SUNNICA ENERGY FARM

8.44 Applicant's Response to the Joint Local Impact Report

Planning Inspectorate Scheme Reference	EN010106
Application Document Reference	EN010106/APP/8.44
Author	Sunnica Energy Farm Project Team

Version	Date	Status of Version
Rev 00	22 November 2022	Deadline 3 Submission

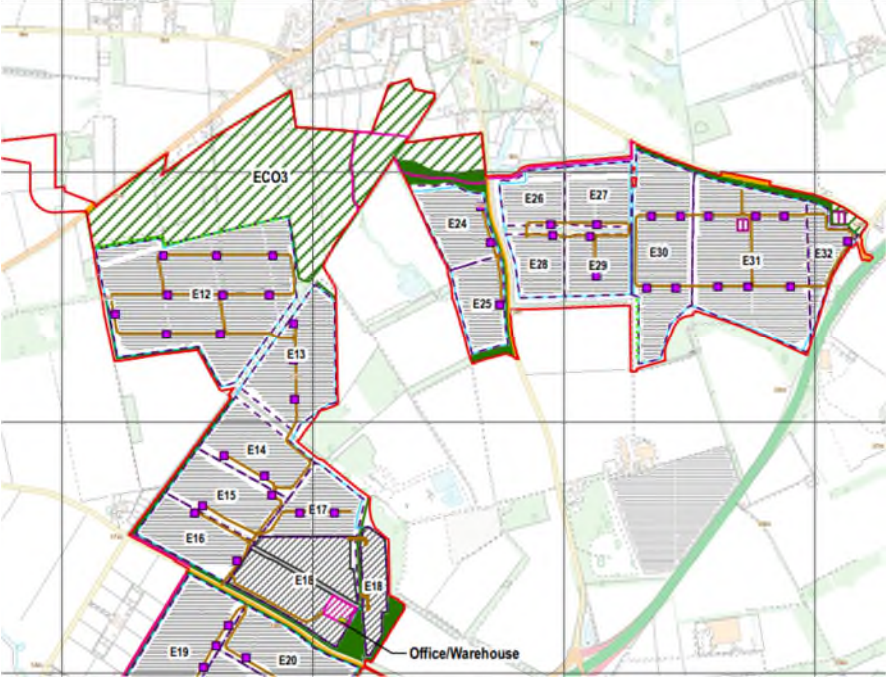
8.72 to 8.78	<p>Havacre Meadows and Deal Nooks County Wildlife Site</p> <p>The Works Plans (sheet 8, [APP-007]) show the proposed cable route A will go through Havacre Meadows and Deal Nook County Wildlife Site. The County Wildlife Site supports semi-improved grassland, woodland, scrub and open water, as well as willow carr.</p> <p>The Councils require confirmation as to whether or not the embedded mitigation of a 30m buffer zone will be breached by the proposed cabling works. If a trenchless crossing is to be utilised, the Councils seek a detailed drawing to demonstrate how the 30m buffer zone will be implemented. Also, how deep the tunnel will be and whether this will impact the habitats present, including hydrology.</p> <p>The Councils require monitoring of the construction impacts on the Havacre Meadows and Deal Nook County Wildlife Site to be incorporated into the Framework</p>	<p>Horizontal Directional Drilling is being proposed at Havacre Meadows and Deal Nook CWS with entry and exit pits set back from the boundary of the CWS to conform to the 30 m buffer zone to increase confidence that this receptor will not be adversely impacted, as secured through the Framework Construction Environment Management Plan. The profile of the cable pipe is very small compared to the extent of the aquifer and therefore is not anticipated to impede groundwater flow contributing baseflow to rivers and other groundwater dependent water features. No monitoring is therefore required.</p>
